Attachment D to Addendum 1

PROJECT:
75 Mental Health RRTP Beds

Window Details

10 2 APC WALL WDW JAMB REV 1 AS500 AD1-01 1 1/2" = 1'-0"

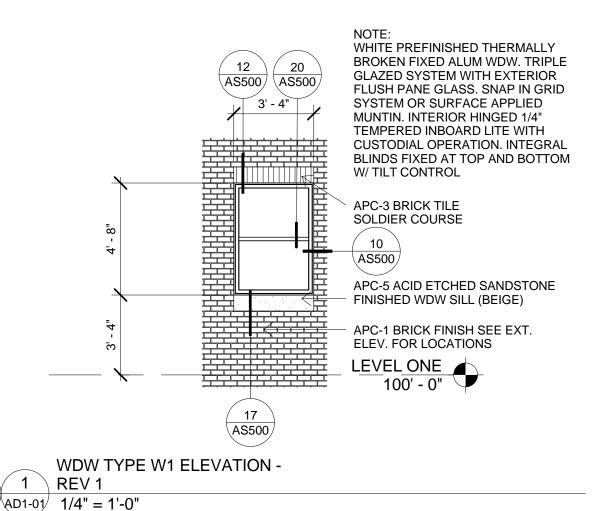
10" APC EXTERIOR WALL PANELS SANDBLASTED STUCCO FINISHED OR BRICK **RETURN APC** TILES WHERE INDICATED **EXTERIOR** (SHOWN DASHED). FINISH INTO OPENING. PROVIDE 1" X 3" WD **BLOCKING FOR WDW FIXING** WHITE PREFINISHED THERMALLY BROKEN WDW TRIM SET ALUM. WDW. TRIPLE GLAZED WDW WITH IN BED OF SLNT EXTERIOR FLUSH PANE GLASS. HORIZONTAL SNAP IN GRID SYSTEM OR SURFACE APPLIED MUNTIN. INTERIOR HINGED 1/4" TEMPERED INBOARD LITE WITH CUSTODIAL OPERATION. INTEGRAL BLINDS FIXED AT TOP AND BOTTOM W/ TILT CONTROL

12 APC WALL WDW HEAD REV 1 AS500 AD1-02 1 1/2" = 1'-0"

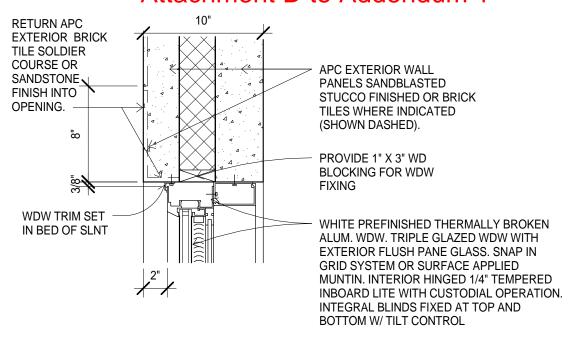
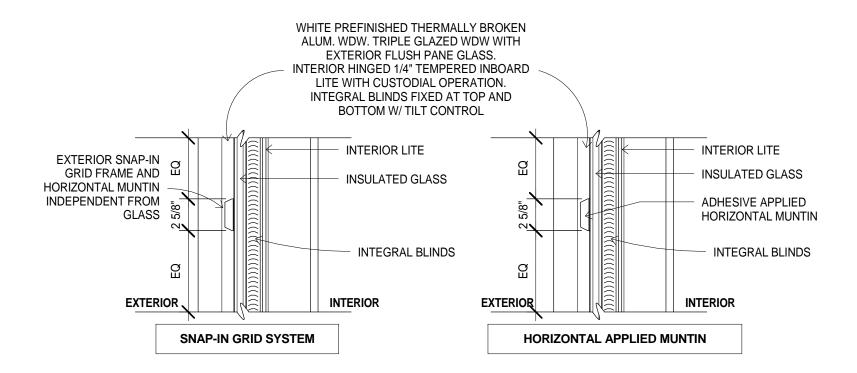
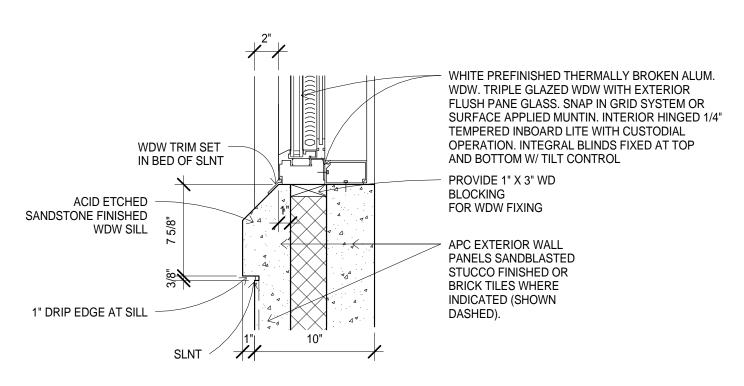
APC WALL WDW HORIZ MUNTIN 20 2 WINDOW MANF. OPTIONS REV 1

3 APC WALL WDW SILL REV 1 AS500 AD1-02 1 1/2" = 1'-0"
